SERVICE BULLETIN

FUJI HEAVY INDUSTRIES LTD.

FAS : FAS-051

1. SUBJECT : Change of Cigar Lighter Installing Location.
2. AIRCRAFT AFFECTED : FA-200 Series Serial Nos. 1 thru 126 aircrafts on which a Cigar Lighter is installed.
3. PRIORITY : Essential.
4. REASON : In order to prevent possible fire which may be caused when the subject lighter absorbs leaked fuel or oil, since the lighter is located under fuel pressure indicator and lubricating oil pressure indicator.
5. DESCRIPTION : Cigar lighter installing location to be changed as shown in figures 1 and 2.
6. ACCOMPLISHMENT : At the next 50 hours check or 100 hours check.
7. APPROVAL : JCAB Approval (NO-TOKYO-013) March 1, 1971.
8. PARTS REQUIRED : The following parts are required to perform the modification:

FIG. 1

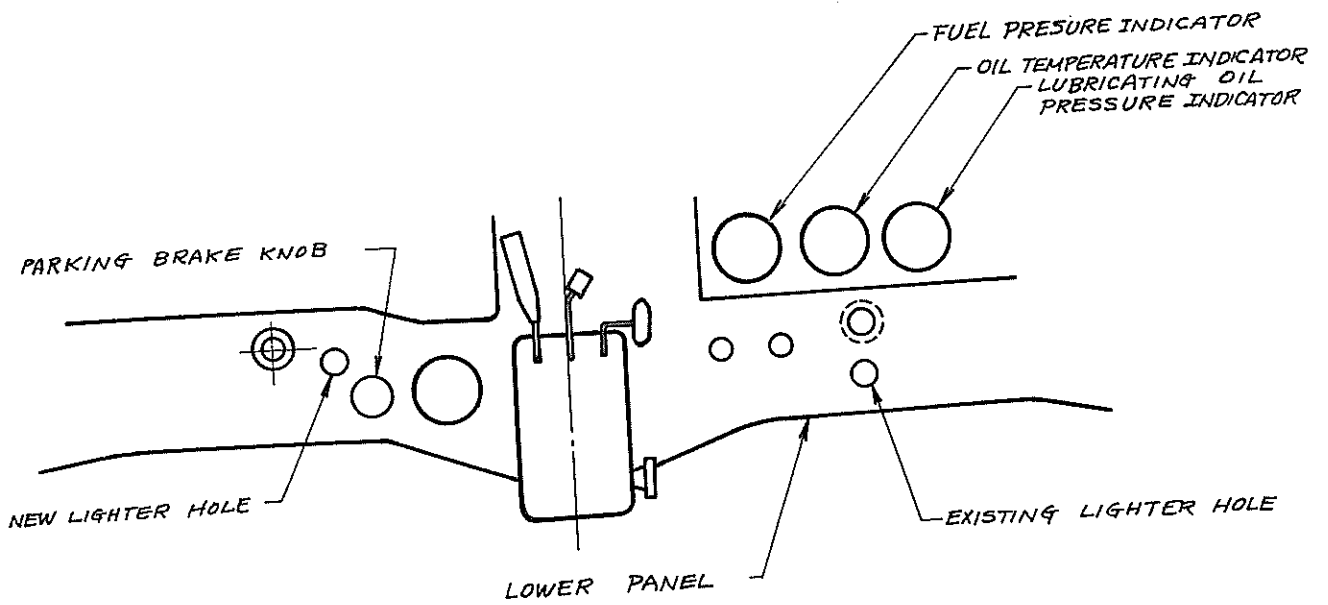
- a. Pull out cigar lighter by removing nuts securing the lighter at the back of lower panel, and then separate harness.
- b. Using splice, 320559, connect new harness, H2A16, with the harness separated in the above step.
- c. Make new installing hole as illustrated in figure 2.
(Apply zinc chromate primer to bare metal.)
- d. Lead the harness extended in the step 2 to the new installing hole, and secure with tying in suitable position.
- e. After joining the lighter and harness with solder, install the lighter with nuts at the back of lower panel.
- f. Check for proper connection or short-circuit, then check for proper ignition of the installed cigar lighter.
